Notification Date: September 6, 2022

PRODUCT CHANGE NOTIFICATION

SIM Slot Replacement

Figure 1: Revision on the Packaging Label

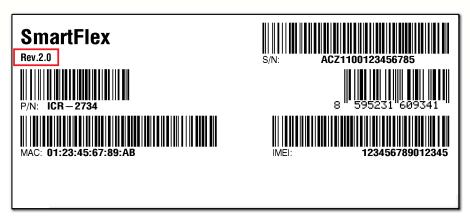
- SmartStart (BB-SL305)
- SmartFlex (BB-SR303, BB-SR304, BB-SR305, BB-SR307, BB-SR308, BB-SR309, BB-SR310)
- SmartMotion (BB-ST352, BB-ST355)
- See the revision number printed on the packaging box or the product label to identify affected routers. Affected routers have revision 2.0; see Figures 1 and 2.
